# Access Compliance Report

## Public Rights-of-Way

### (Curb Ramps)

Intersection ID: 32289	Main Street: ALLYSON PARK DR	Cross Street: DONNA VE LN	Location: SE
ADA ID: CA3BC81DBA32	Ramp Type: PerpDiag	Initial Pass/Fail: Fail	Overall Compliance: No
Severity Score: 25			
Codes/Mitigation Info/Possible Solution		Field Measurements/Component Compliance

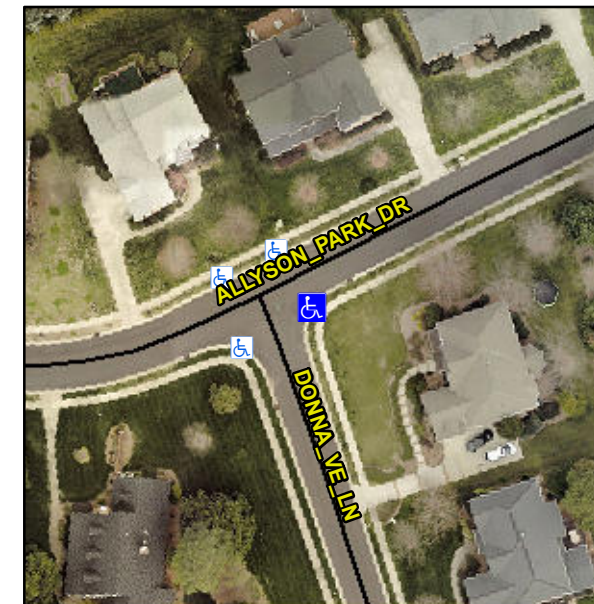
**R304.5.3**

Compliance	Description	Data	Compliance	Description	Data
N/A	Ramp Length (in)	58.5	Yes	Ramp Slope (%)	8.0
Yes	Ramp Width (in)	48.0	No	Ramp XSlope (%)	9.3
N/A	Flare Type LT	N/A	N/A	Flare Type RT	N/A
N/A	Flare Slope LT (%)	N/A	N/A	Flare Slope RT (%)	N/A
N/A	Flare Traversable LT?	N/A	N/A	Flare Traversable RT?	N/A
N/A	Landing Length (in)	N/A	N/A	DWS Provided?	N/A
N/A	Landing Width (in)	N/A	N/A	DWS Contrast?	N/A
N/A	Landing Slope (%)	N/A	N/A	DWS Length (in)	N/A
N/A	Landing X Slope (%)	N/A	N/A	DWS Full Width?	N/A
N/A	Landing Curb? (Y/N)	N/A	N/A	DWS Offset (in)	N/A
N/A	Shared Landing?	N/A			
N/A	Gutter Ponding?	N/A	N/A	Gutter Slope (%)	N/A
N/A	Gutter Lip Ht (in)	0.5	N/A	Gutter X Slope (%)	N/A
N/A	Painted X Walk1?	No	N/A	Painted X Walk2?	No
	X Walk 1 Direction	To N		X Walk 2 Direction	To W
N/A	X Walk 1 Width (in)	N/A	N/A	X Walk 2 Width (in)	N/A
	X Walk 1 Slope (%)	3.4		X Walk 2 Slope (%)	13.6
	X Walk 1 X Slope (%)	9.6		X Walk 2 X Slope (%)	0.3

N/A	Ramp inside XWalk1?	N/A	N/A	Ramp inside XWalk2?	N/A
	Road Slope (%)	7.7	N/A	Clear Space?	N/A
	Road X Slope (%)	8.9	N/A	Clear Space to XWalk (in)	N/A
N/A	Any Obstructions?	N/A	N/A	Storm Grate/Utility Hazard?	N/A
	Obstruction Type			Storm Grate/Utility Type	
		N/A			N/A
			Yes	Surface Condition? (G/P)	Good

**Remove & Replace Curb Ramp With Two New Directional Ramps or Equivalent.**
